UNITED STATES PATENT AND TRADEMARK OFFICE

APPLICATION NO.	FILING DATE	FIRST NAMED INVENTOR	ATTORNEY DOCKET NO.	CONFIRMATION NO.
10/643,642	08/19/2003	Steven S. Bordewick	AP.001 US1	6985
7590 05/04/2004			EXAMINER	
Kathleen R. Terry 2417 Como Avenue St. Paul, MN 55108			MITCHELL, TEENA KAY	
			ART UNIT	PAPER NUMBER
			3743

Office Action Summary

DETAILED ACTION

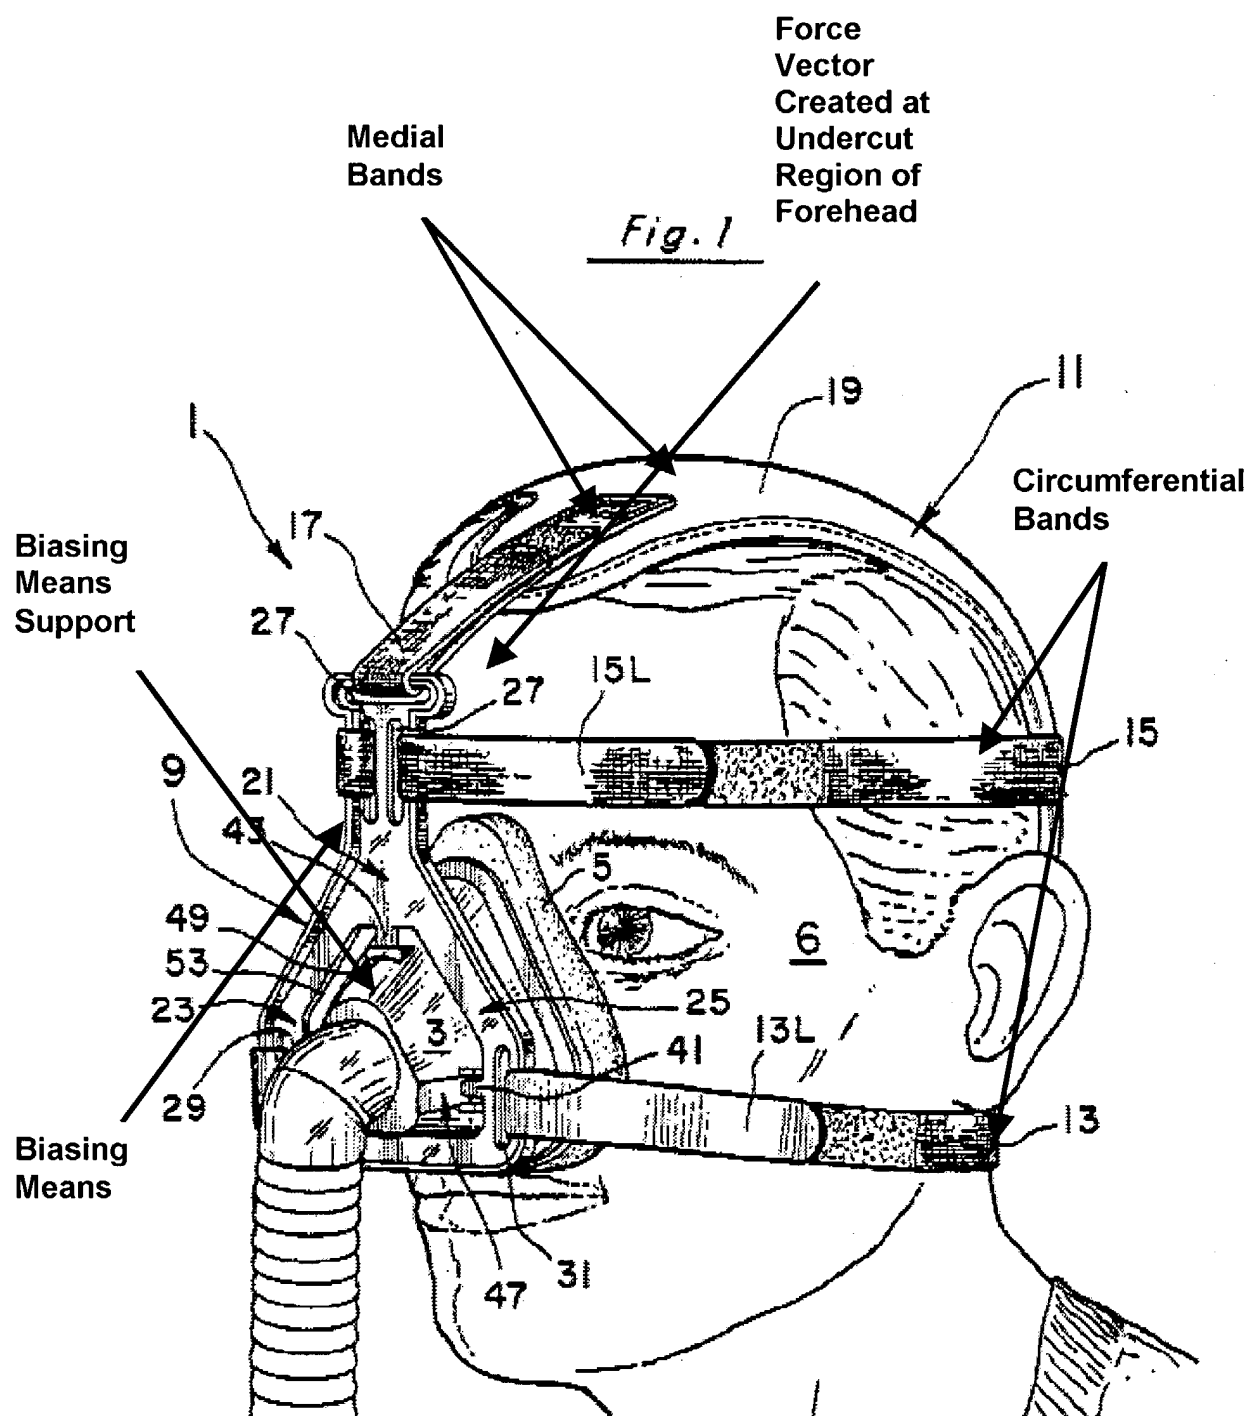
Claim 13 is rejected under 35 U.S.C. 102(b) as being anticipated by Ogden et.al. (5,662,101).

Ogden in a facemask discloses (as best understood by the examiner):

- a mask support (Figs. 1-3)

- wherein the circumferential and medial bands (See Fig. 1 illustrated below) create a stable platform for the biasing means support (See illustration of Fig. 1 below) by encircling the head so as to clamp the support to the head (Figs. 1-3) with force vectors created at the undercut region of the forehead and the undercut region of the inion protrusion and the resultant radially oriented force vectors are established at the region where the circumferential band (see illustration of Fig. 1 below) contacts the head, wherein the mask support is stabilized to resist lateral vector forces. As the medial and circumferential bands are adjusted the vector forces claimed are provided by the mask support taught by Ogden.

The examiner in claim 13 reads vector forces as, pressure, which is applied to the mask of Ogden when the bands are tightened (inasmuch as the vector forces have no structure limitation and have not been depicted in any figure). When the bands of Ogden are tightened a force vector would be created at the undercut of the forehead region by adjustment of band 15 and adjustment of band 13 creates a force vector at the undercut region of the inion protrusion. Once the bands (13, 17, and 15) are adjusted the mask support is stabilized to resist lateral vector forces (note Fig. 1 above).
